RS-06-156

U. S. Nuclear Regulatory Commission  
ATTN: Document Control Desk  
Washington, DC 20555-0001Quad Cities Nuclear Power Station, Units 1 and 2  
Renewed Facility Operating License Nos. DPR-29 and DPR-30  
NRC Docket Nos. 50-254 and 50-265Subject: Response to Request for Additional Information Related to Extended Power  
Uprate Operation Commitments

### Additional Information Related to Extended Power Uprate Operation

### High Frequency Plots for QCNPS Unit 2 MSL Strain Gage Measurements

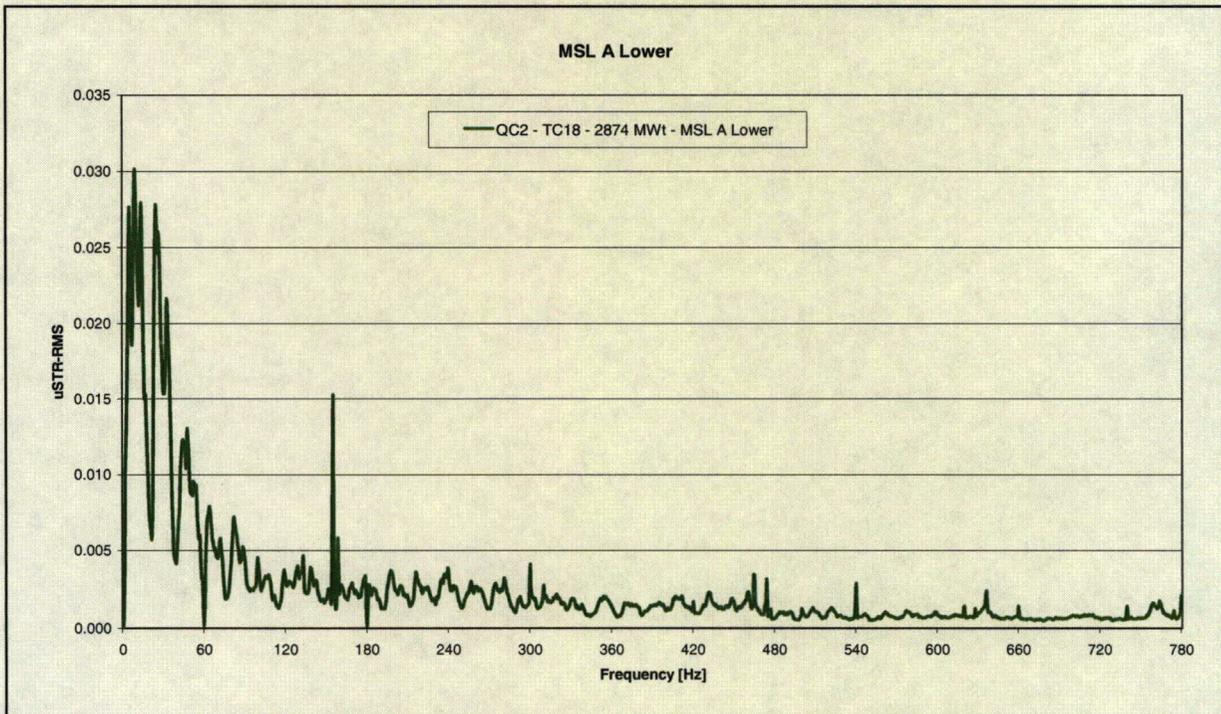
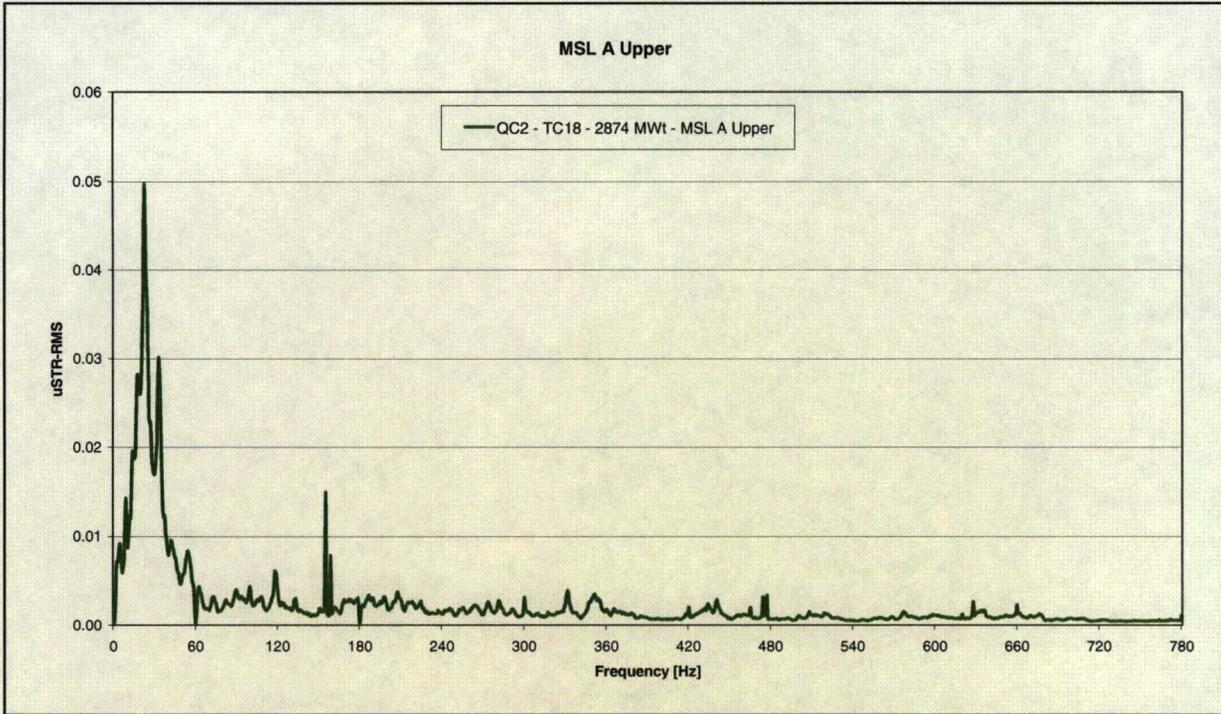
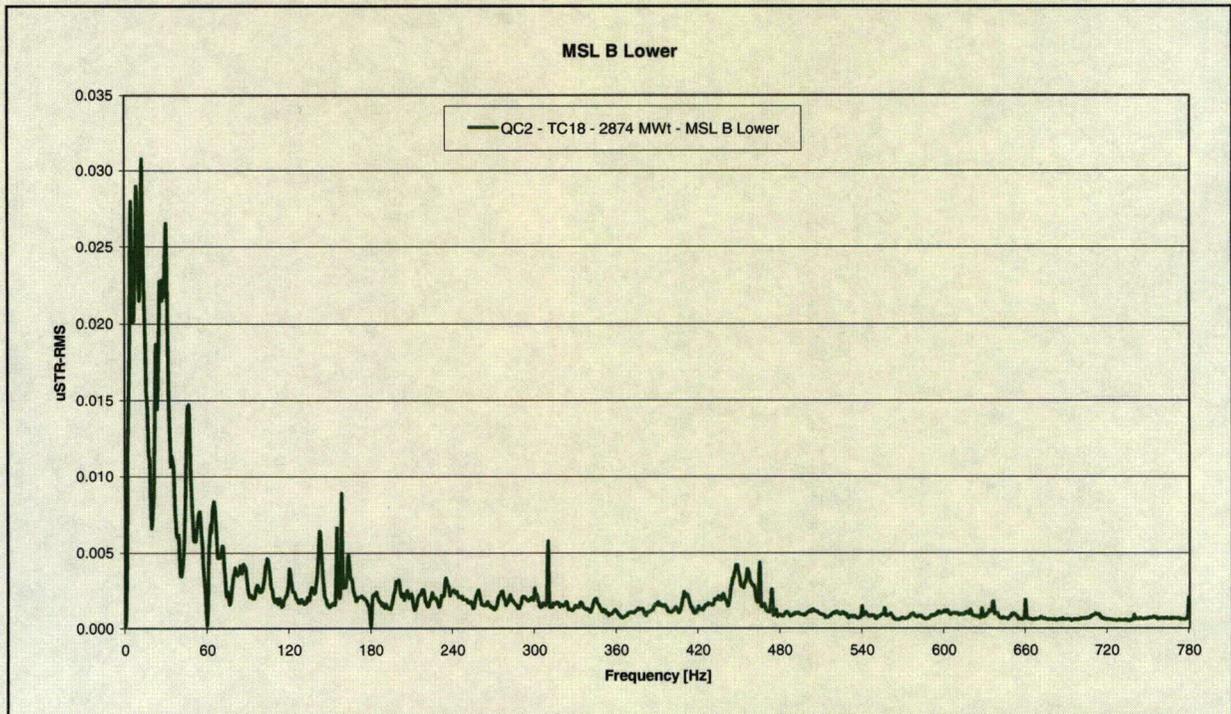
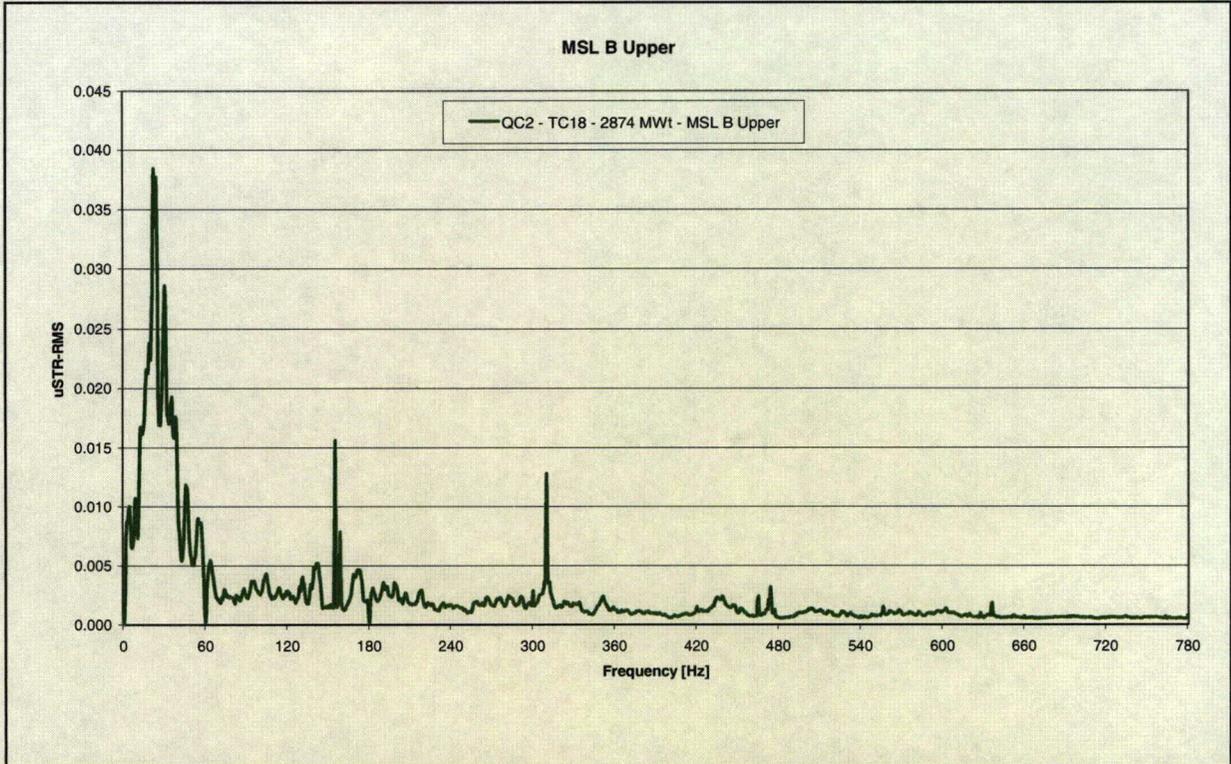
Figures 10 to 13 in Exelon Report AM-2006-002 show the QC2 MSL B vibration spectra at OLTP and EPU conditions prior to ASB installation for frequencies up to 1 kHz. The figures show harmonics at twice and three times the fundamental singing frequency (about 320 and 480 Hz). What is the potential impact of any new resonances that might be excited at higher frequencies due to the installation of the ASBs?

The MSL strain gage data collected from QCNPS Unit 2 with the ASBs installed from TC 18 at 2874 MWt was used to assess the higher frequency content of the pressure oscillations in the MSLs. FFTs of the strain gage measurements from the "A" and "B" MSLs were calculated to 780 Hz, the maximum frequency available based on the data acquisition rate, and are provided in Attachment 2. The "A" MSL does not show frequency content above 200 Hz. The "B" MSL does contain multiples of the acoustic frequency at 155 Hz, but does not contain other higher frequency content. The magnitude of the 310 Hz and 465 Hz multiples are smaller in magnitude and will not generate significant load in the piping or the steam dome.

Functionally, the ASB performance improves with increasing frequency (i.e., oscillating pressure magnitudes are more effectively reduced at higher frequencies). Consequently, the higher frequency content of the pressure oscillations in the MSLs is not significant and will not cause a significant increase of the loading in the MSLs or on the steam dryer.

Figure 1: Unit 1 MSL "A" Strain Gage Measurements at 2955 MWt

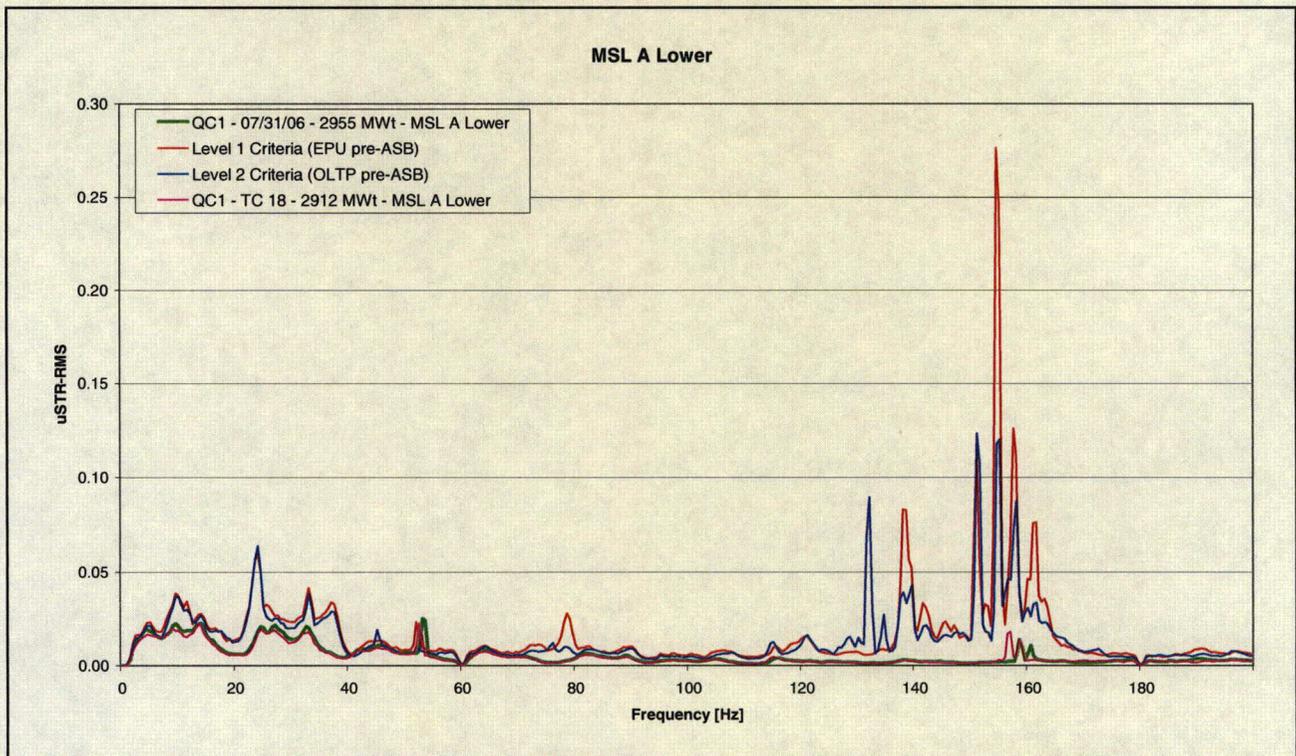
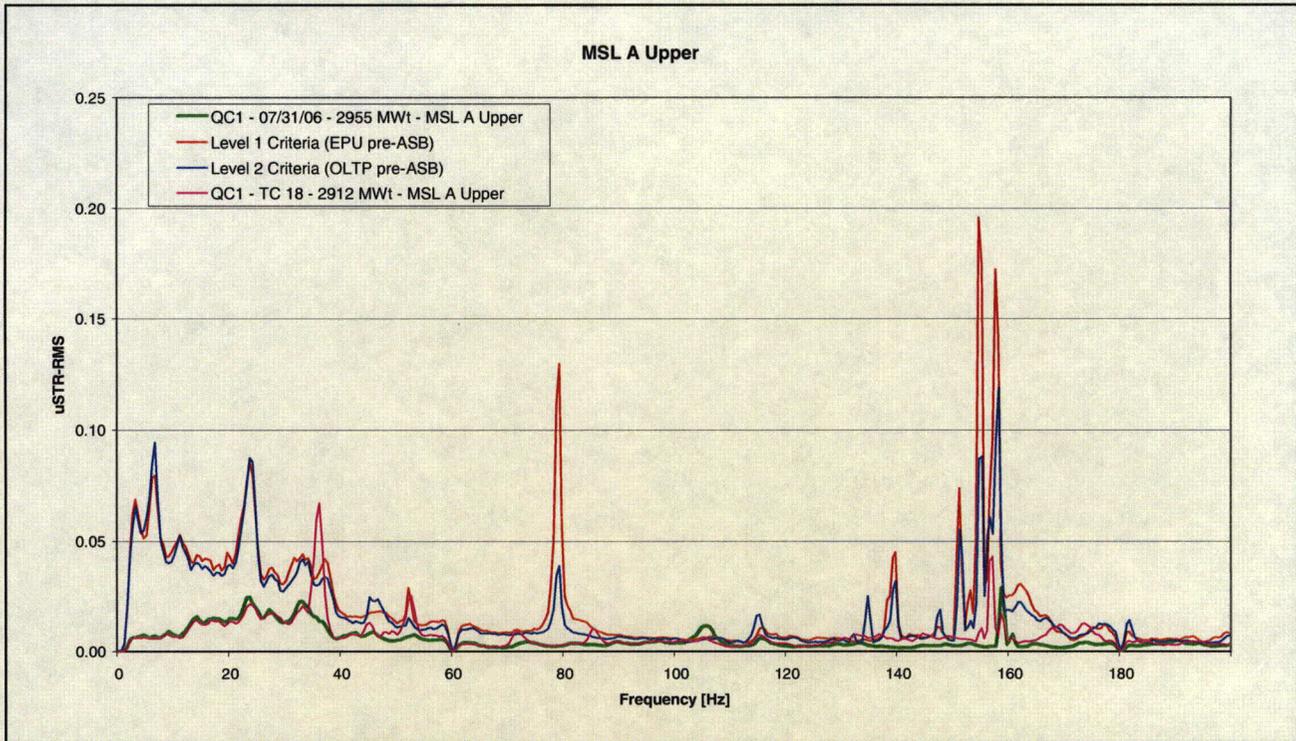
Figures 1 through 4 present the QCNPS Unit 1 main steamline (MSL) strain gage data at 2955 MWt compared to the acceptance criteria and the 2912 MWt data collected during the start-up test. A review of these figures in the low frequency range shows very consistent frequency content for all the MSL measurements that is below the pre-ASB measurements. In addition, the 36 Hz peak on the "A" MSL upper location and the 48 Hz peak at the "B" MSL upper location measured at 2912 MWt are reduced significantly in the 2955 MWt data at these locations.

Figure 5: Unit 1 and Unit 2 "A" MSL Strain Gage Max-Min Trend Plots Through 8/22/06

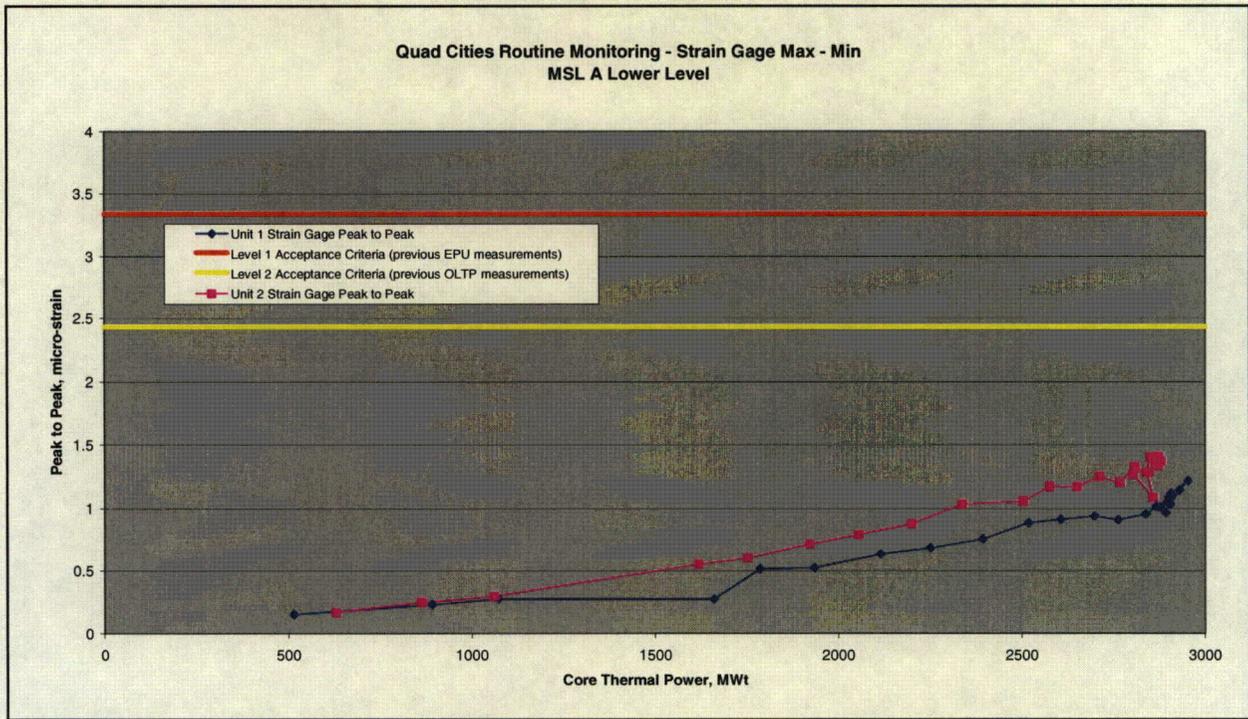
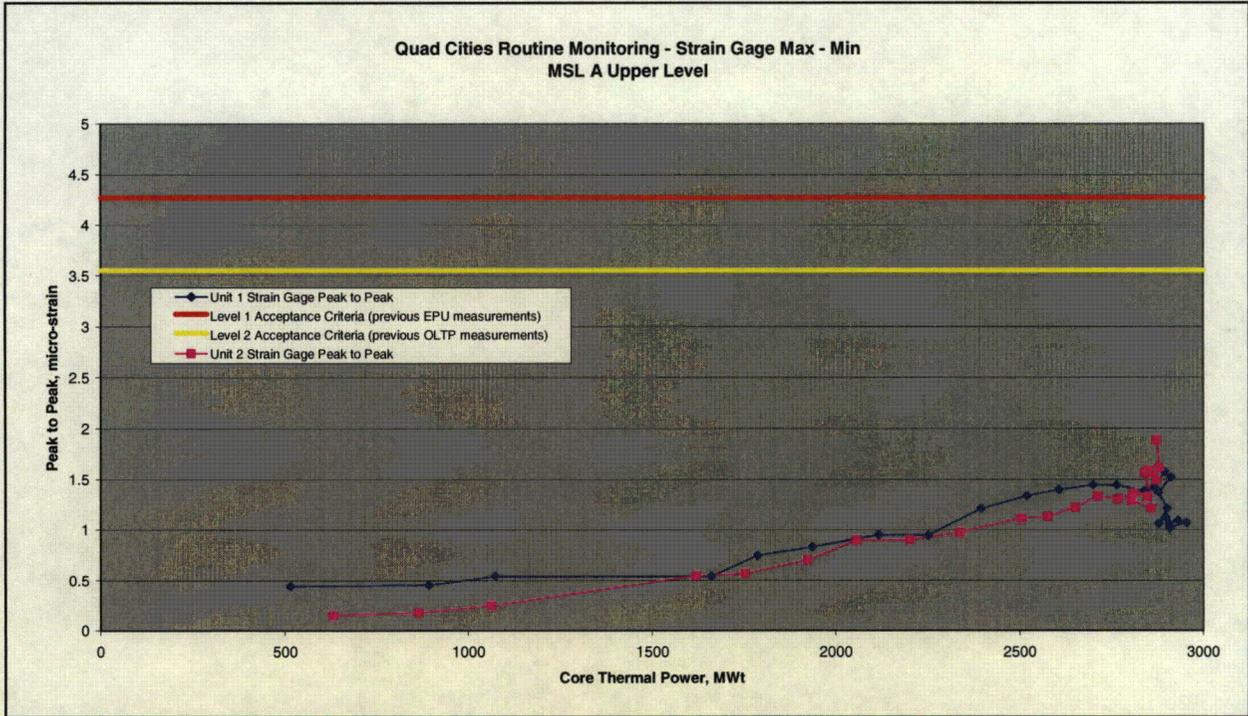
The change in the max-min values for these MSL measurements supports this conclusion. The max-min strain gage data trend plots from each unit are provided in Figures 5 through 8 below. As seen from these plots, the MSL strain data on both units behave very similarly with increasing power levels. The max-min values increase following a flow velocity squared trend, without indication of higher order increases as seen when acoustic resonance was occurring in the MSLs. The velocity squared increase is suggestive of turbulence phenomena, as opposed to resonant acoustic response which tends to increase at a much higher rate with flow increase.
